Version 4

Safety Recall: 2020-22 Odyssey Seat Weight Sensor (DTC U3000-49)

Supersedes 24-020, dated March 21, 2024, to revise the information.

Under REPAIR PROCEDURE, step 12 and 13 were updated.

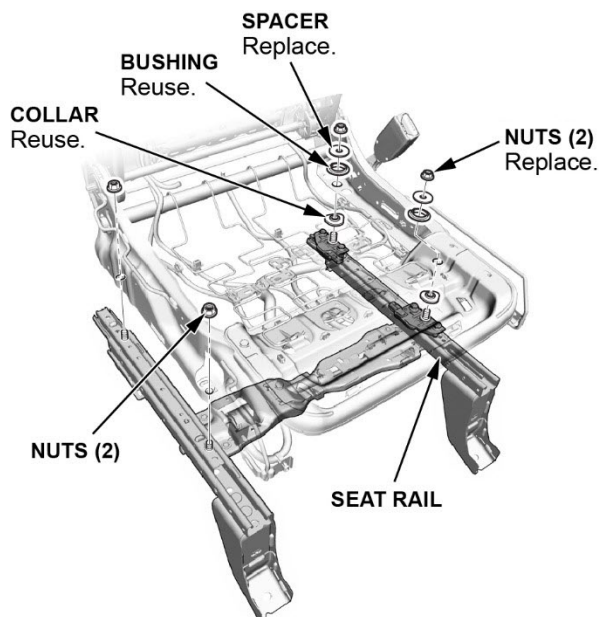
12. Remove the 4-seat frame mounting nuts, then remove the front passenger seat rail as an assembly.

NOTE: Note the color and location of the collars and the bushings during disassembly.

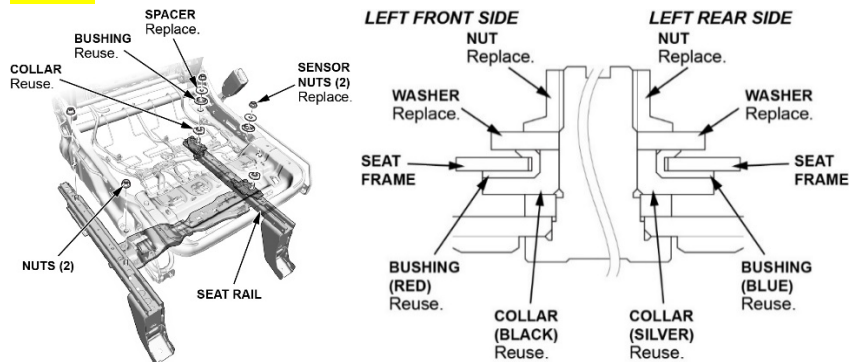
13. Install the front passenger's seat rail as an assembly to the seat frame as shown, and loosely tighten the mounting nuts.

NOTE: The bushings and collars can be identified by their color. Make sure to reinstall the bushings and collars as shown.
